Subject: Waterford 3 SES
Docket No. 50-382
License No. NPF-38
Technical Specification Change Request NPF-38-114

**DESCRIPTION AND SAFETY ANALYSIS
OF PROPOSED CHANGE NPF-38-11 4**

This requests a change to Waterford 3 Technical Specifications (TSs) 3/4.8.1, A.C. Sources - Operating, and 3/4.8.2, A.C. Sources - Shutdown.

FIGURE 1

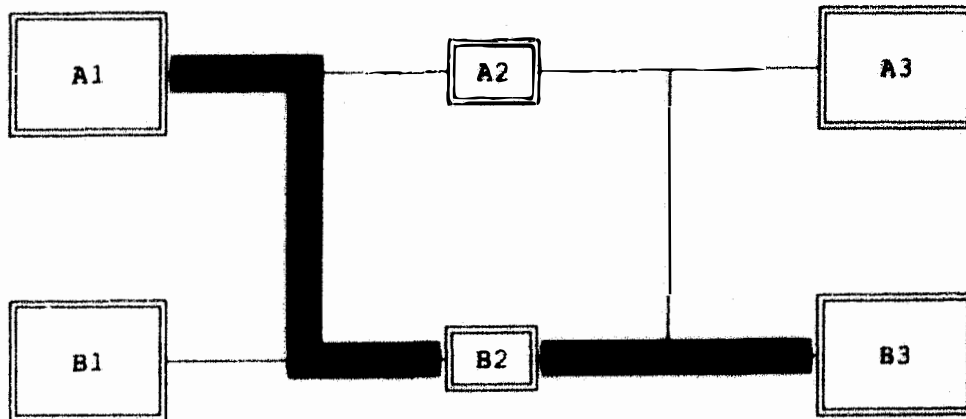
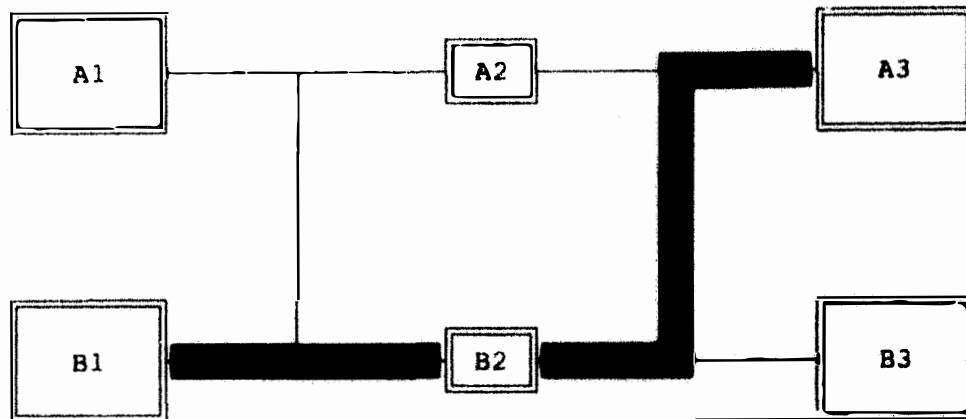
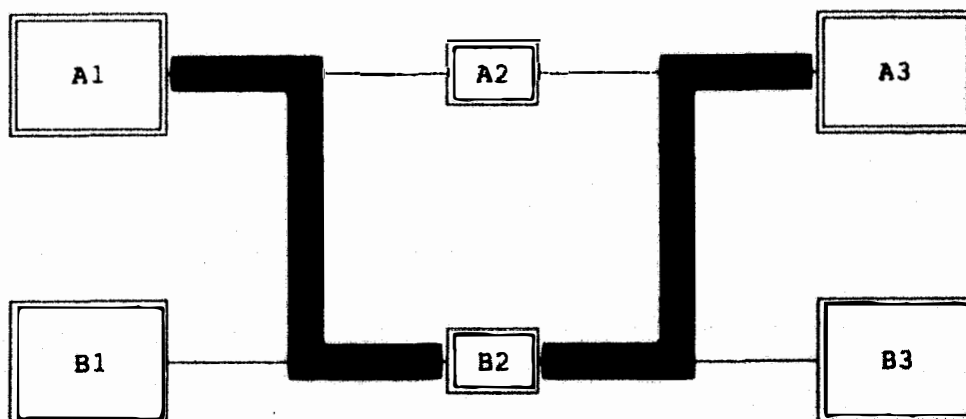
The intent of this surveillance is to confirm operability of the fuel oil flow-path via the pipes connecting the fuel supply lines of the two trains. During a recent Waterford 3 inspection, interpretation of this surveillance was discussed. Entergy Operations believed this surveillance could be satisfied for Transfer Pump B2 by verifying only Alignments 1 and 2 shown in Figure 1 (likewise, the complimentary alignments for Pump A2). However, the inspectors felt the wording of this surveillance specifically required the additional verification that the pump would transfer fuel oil (via the cross connecting pipes) from the storage tank for a diesel to the feed tank of the same diesel. This corresponds to Alignment 3 in Figure 1.

Clearly, verifying Alignments 1 and 2 and their compliments will confirm operability of each pipe segment and the associated valves between the storage tanks and the feed tanks. Verifying Alignment 3 and its compliment is unnecessary since it only provides redundant confirmation of surveillance results for Alignments 1 and 2 and their compliments. Therefore, revising the surveillance to clearly identify only paths 1 and 2 will not reduce its effectiveness.

" . . . verifying that the fuel transfer pump transfers fuel from the fuel storage tank in each train to the diesel oil feed tank of the opposite train via the installed cross connection lines."
